RIVERBEND CROSSING FILING NO. 1

STREET IMPROVEMENT, STORM SEWER, AND SIGNAGE & STRIPING CONSTRUCTION DRAWINGS

EPC STORMWATER REVIEW COMMENTS ARE SHOWN IN ORANGE BOXES WITH BLACK TEXT

RIVERBEND CROSSING
FILING NO. 1
STREET, STORM, & STRIPING
CONSTRUCTION DRAWINGS

Figure SB-2
Outlet Sizing
Application Techniques and Maintenance
Requirements

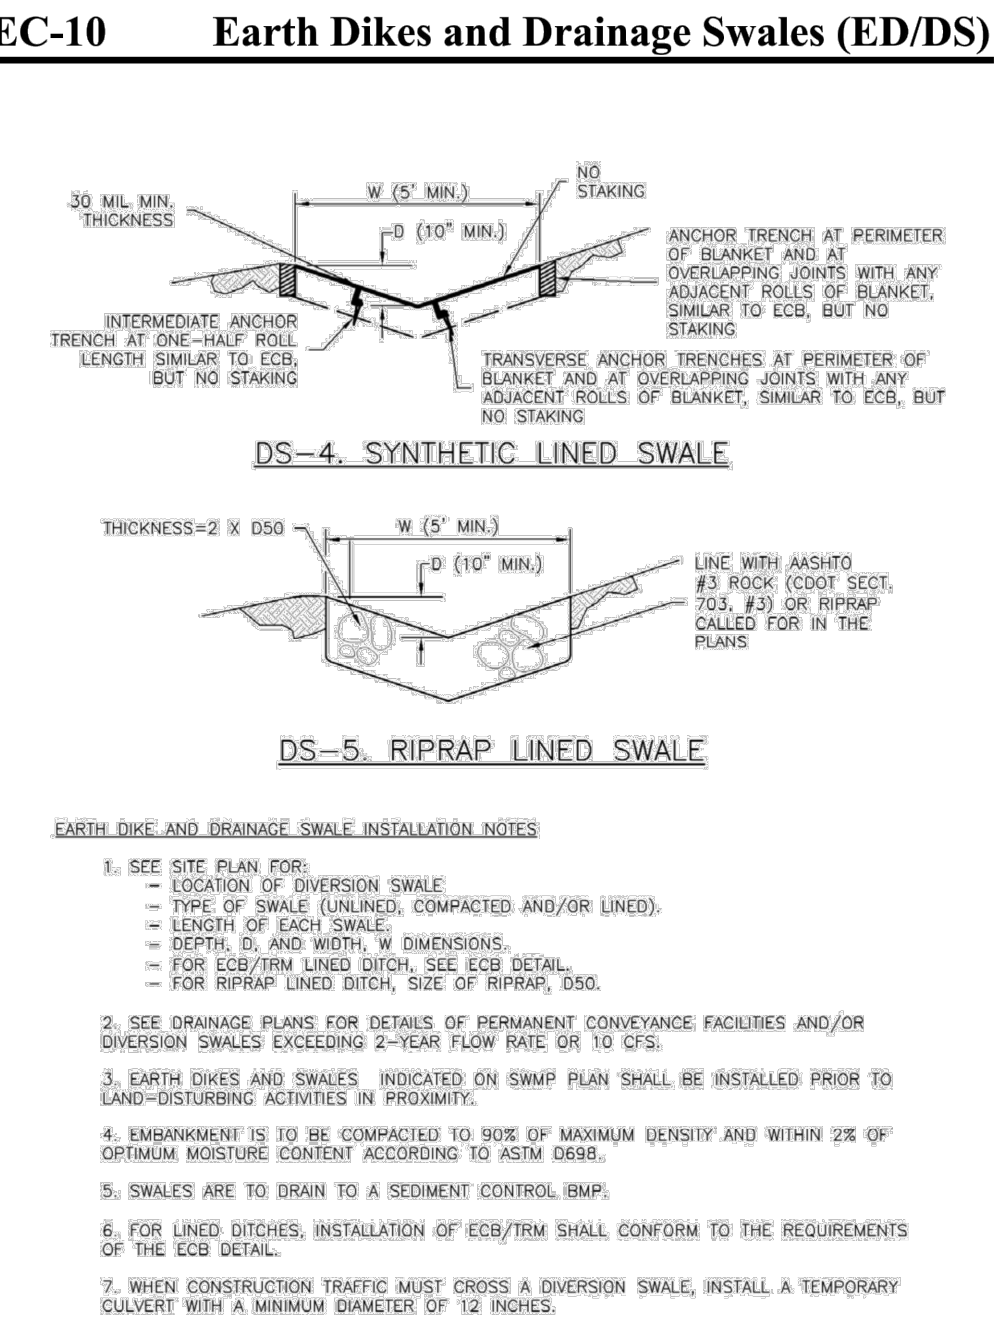
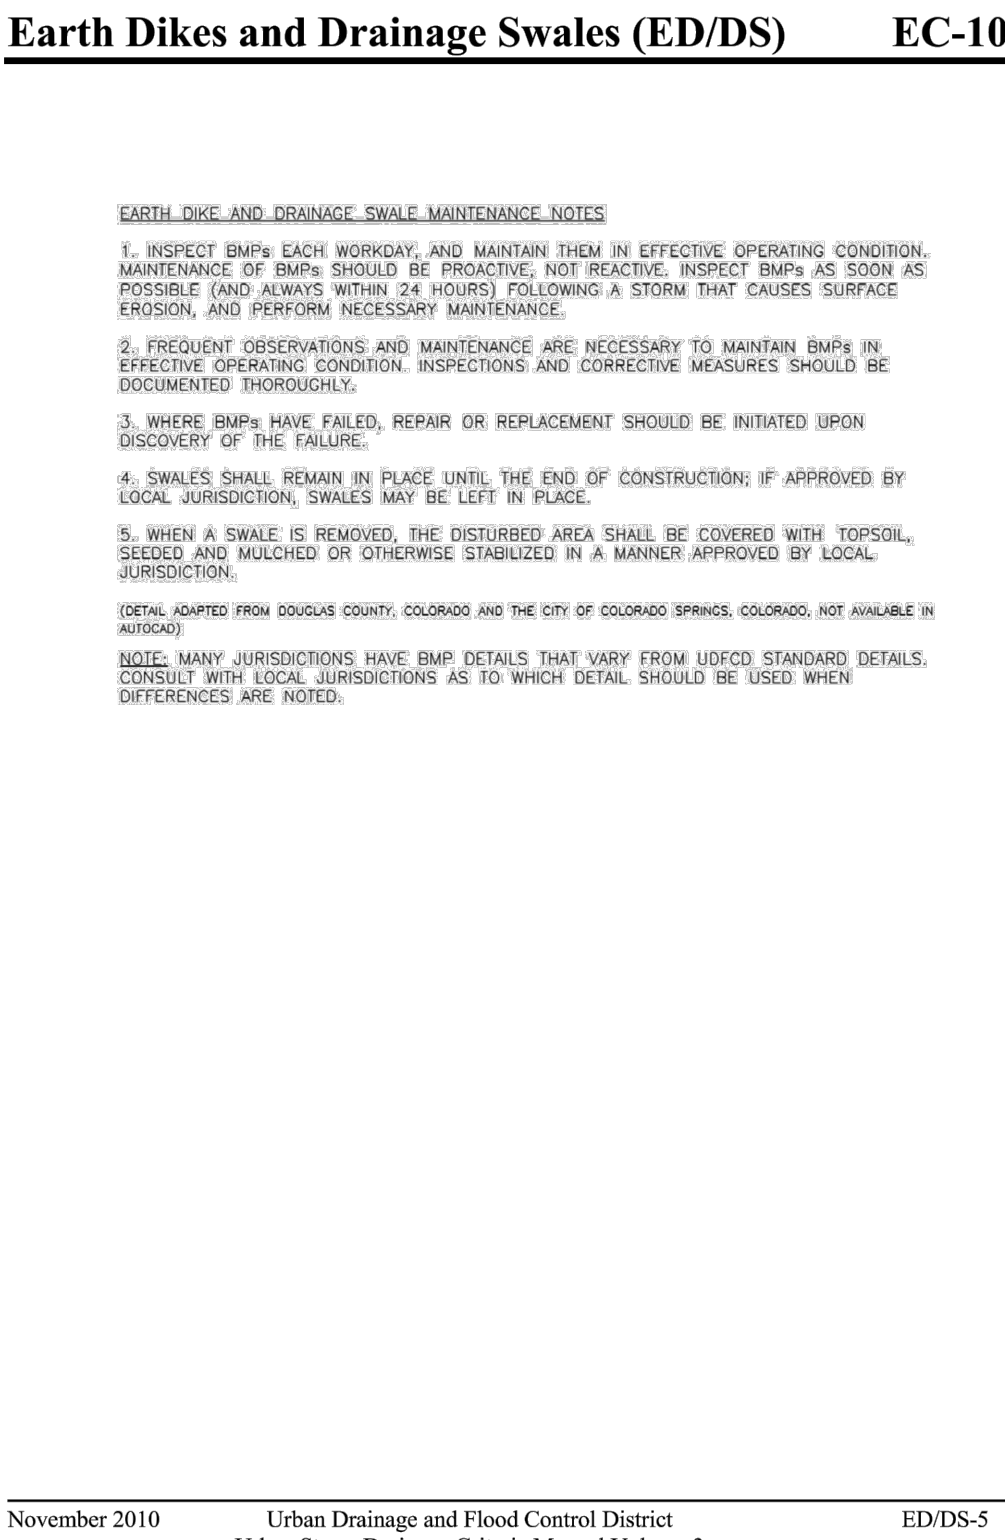
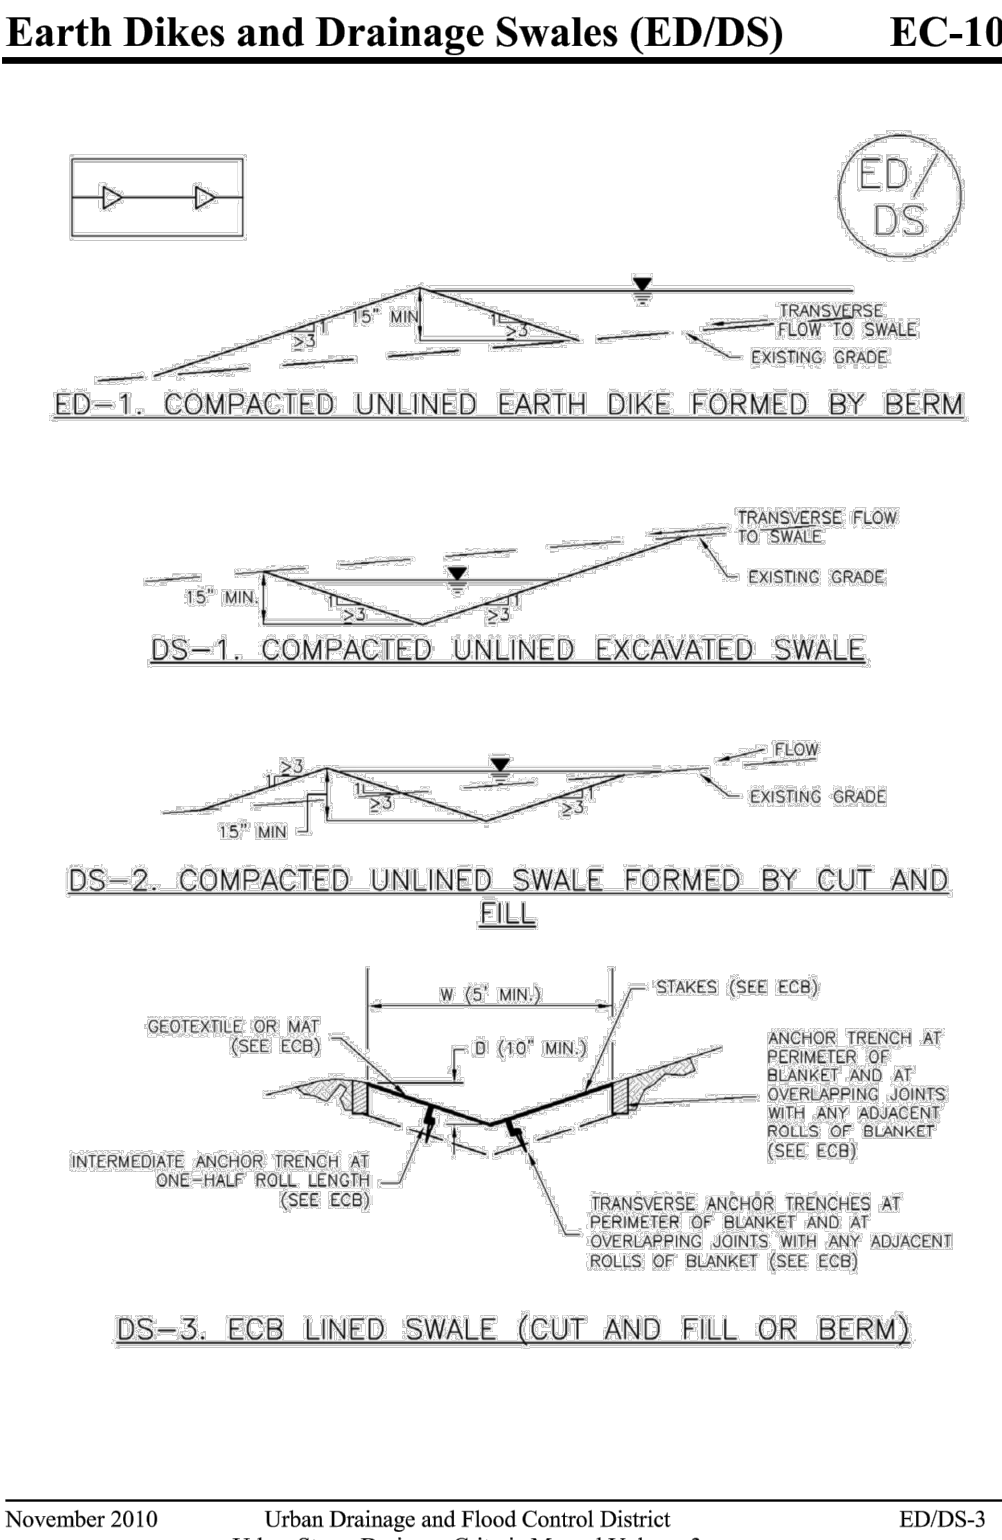
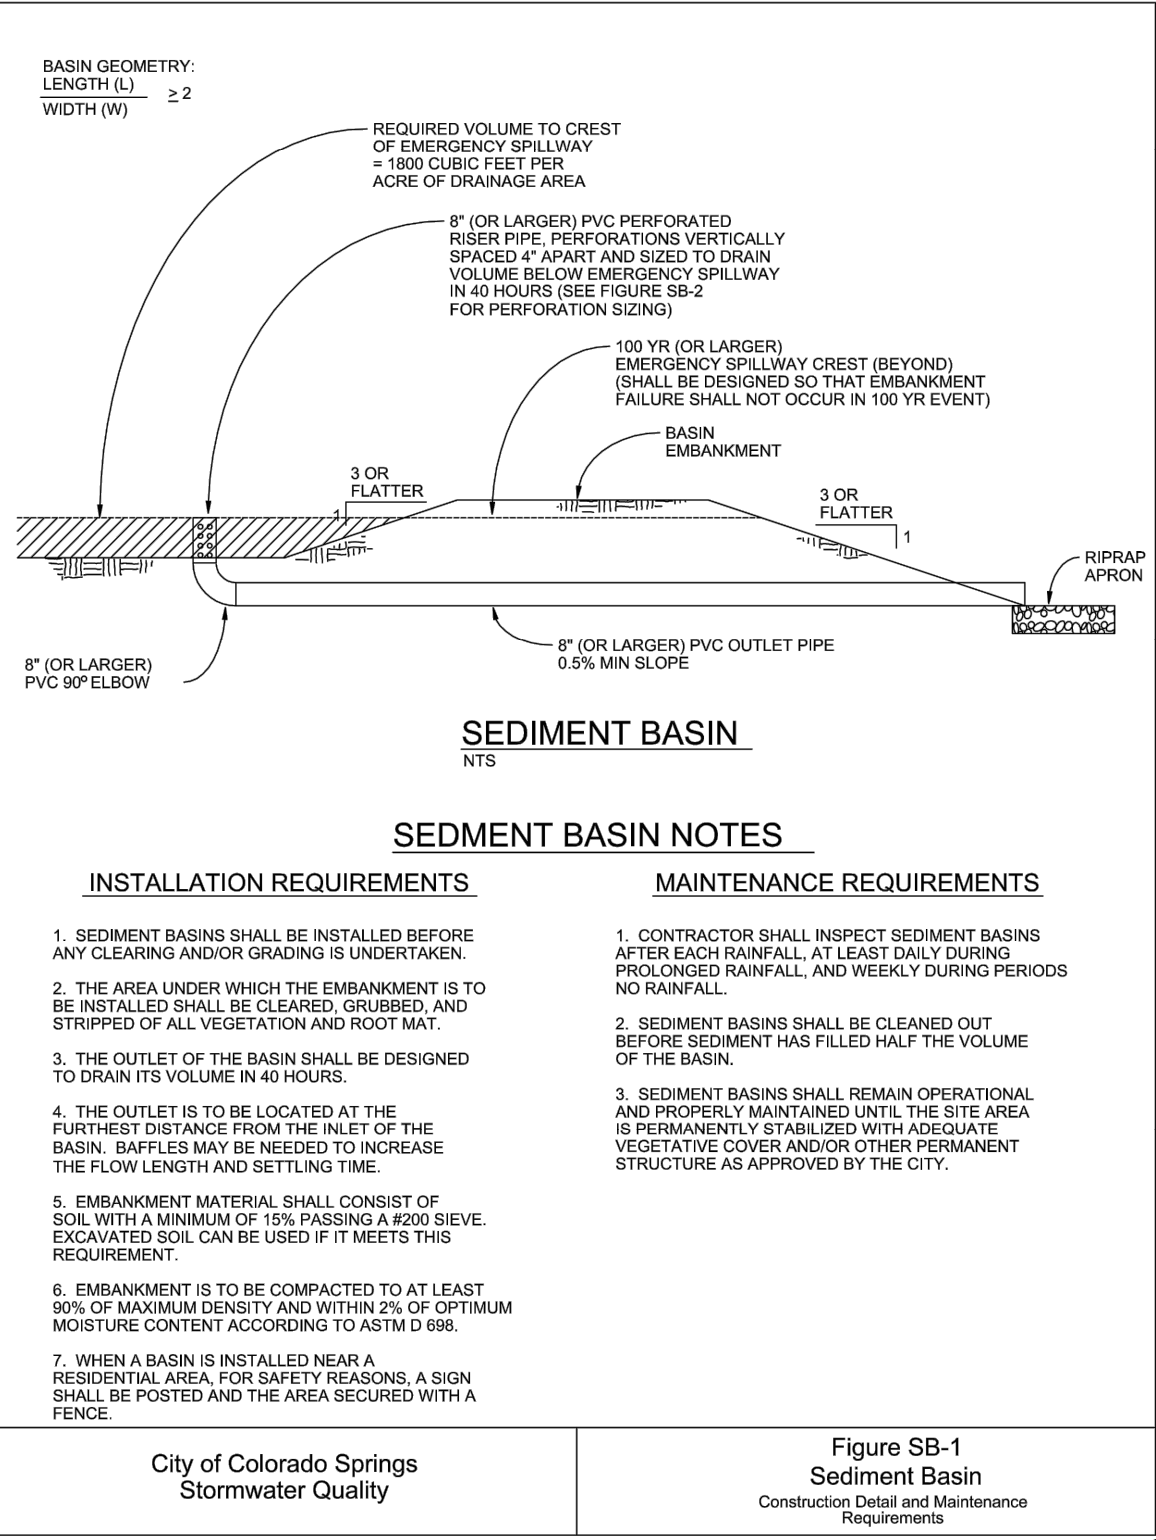
Provide details of temporary sediment basin, including riser pipe perforation sizing, number of rows, required volume, and tributary area to the sediment basin.
